MAIN ROTOR BLADE ABRASION STRIP DAILY INSPECTION REQUIREMENTS

This document supersedes 2100-8R2, adds additional figures to aid in the inspection process, and changes this document to Mandatory Service Bulletin.

**Mandatory
Service Bulletin**

Figure 1 – 1.25 inch (31.8 mm) Chord Abrasion Strip

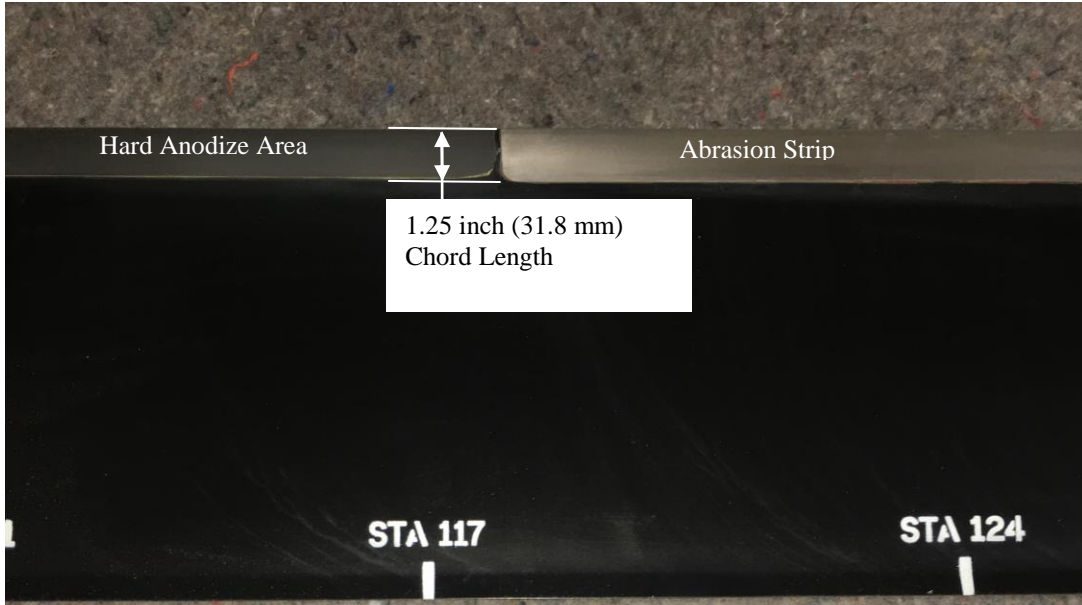
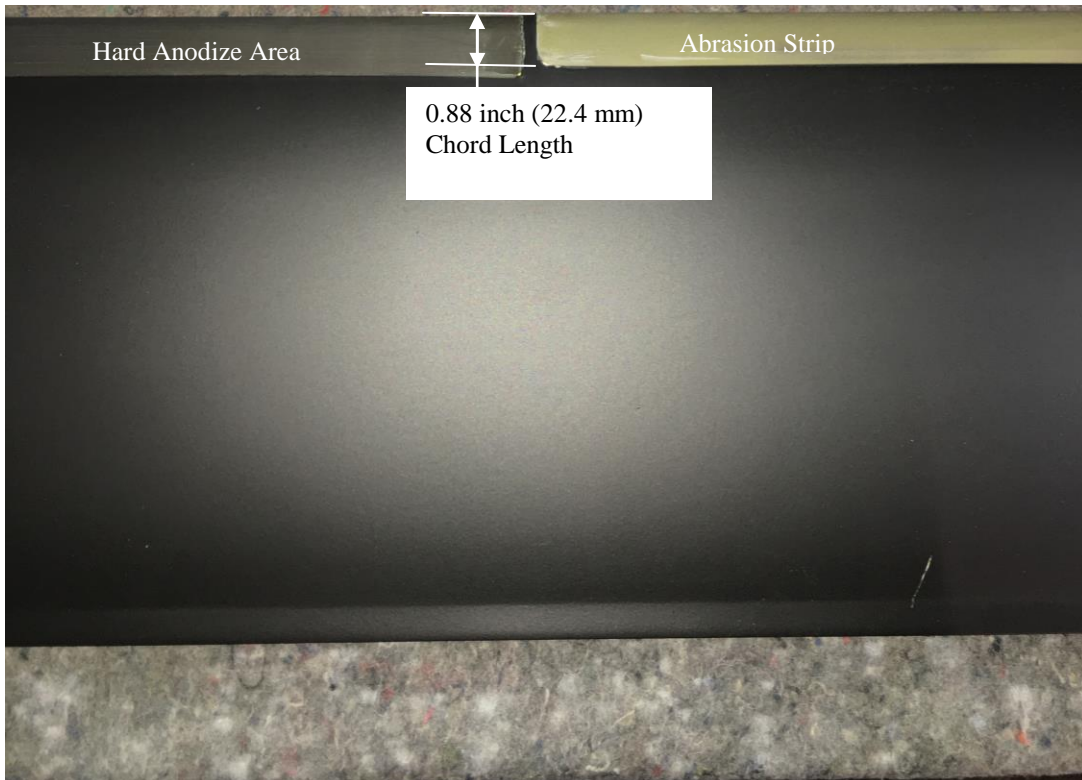
- 1) Determine which Chord Length Abrasion Strip is present on the subject blade and Total Time Since New (TTSN) or since Abrasion Strip Replacement to determine if this Mandatory Service Bulletin is applicable. Reference **Figure 1** and **Figure 2** on Page 2.

- 1) If applicable, Fielded Main Rotor Blades are to be returned to the HTC Factory or an HTC Authorized Repair Station qualified to perform this modification. This modification consists of the removal and replacement of the Abrasion Strip with a 0.88 inch (22.4 mm) chord Stainless Steel Abrasion Strip in accordance with HTCQ-004, Revision I (or later approved revision) Standard Repair Instruction – Main Rotor Blade. Installation of the 0.88 inch (22.4 mm) chord Stainless Steel Abrasion Strip shall constitute compliance and repeating **PART 1** is no longer required.

Figure 3 – Inboard Abrasion Strip Area

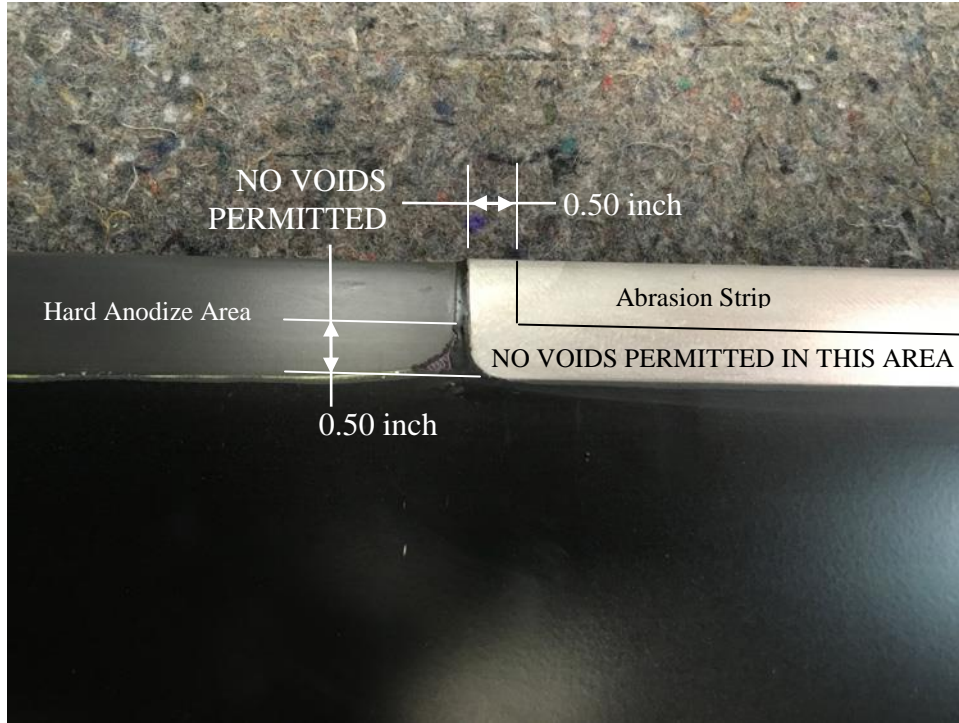
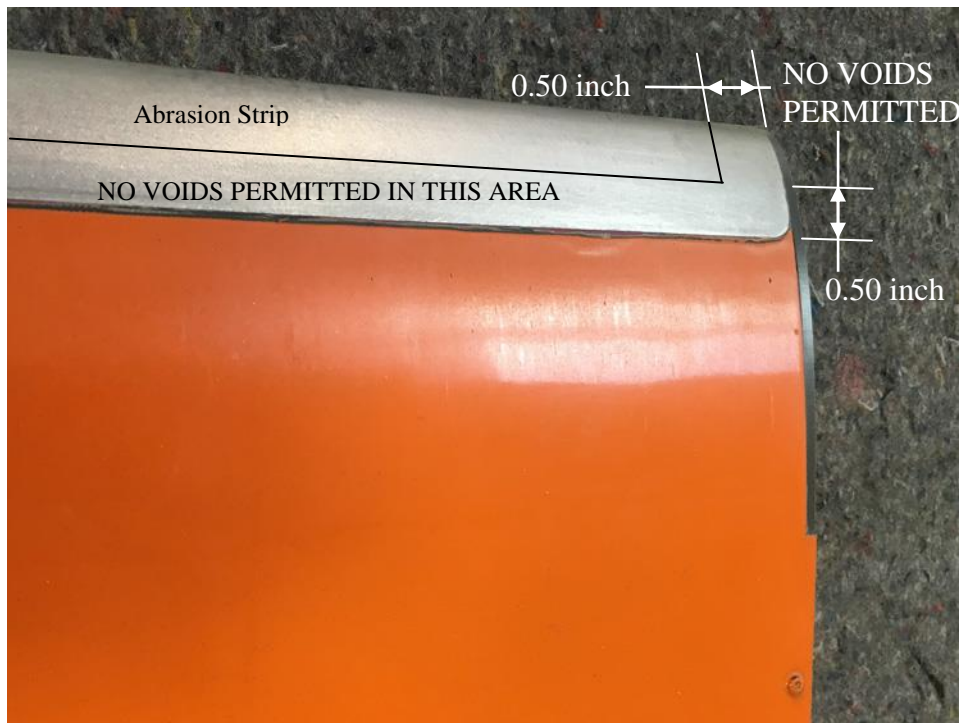
- 5) If any Void is found within 0.50 inches (12.7 mm) of any edge regardless of size, replace the subject blade with another airworthy blade, Reference **Figure 3** and **Figure 4** on Page 5. **Note: Do not attempt a field repair.**

- 6) If a single Void is detected:
 - a. That is fully encapsulated (i.e. is not within 0.50 inches (12.7 mm) of any edge).
 - b. Does not exceed 0.50 square inches (322.6 square mm) in area.the blade may continue to fly so long as it is Reported to and acknowledged by the HTC Factory. Please notify Helicopter Technology Company (HTC) at contact below.

- 7) If multiple Voids are present or a Void exceeds 0.50 square inches (322.6 square mm), replace the subject blade with another airworthy blade. **Note: Do not attempt a field repair.**
